# H5 Network PanoVu Camera Firmware

## Version: V5.5.41 Release Note

(2020-10-20)

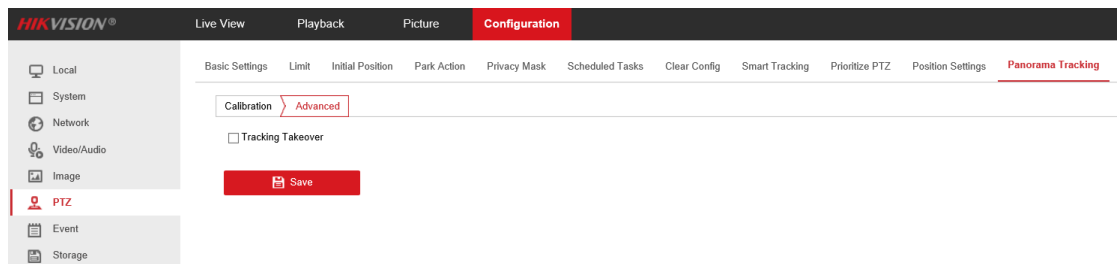
- Support tracking takeover when PTZ smart tracking linkage by panorama channel.

In previous version, the PTZ smart tracking linkage by panorama channel only could track the target in the view of panorama channel. Once the target is out of the view of panorama channel, the PTZ will stop tracking. In order to resolve the issue, introduce the tracking takeover function. After panoramic tracking for a period of time, the device uses the PTZ for tracking based on target detection. The PTZ channel can rotate 360 degrees and track 360 degrees. It has a wider tracking range than panoramic linkage.

Condition: Only both of the VCA resource in PTZ channel and panorama channel are Smart Event, the device supports tracking takeover.
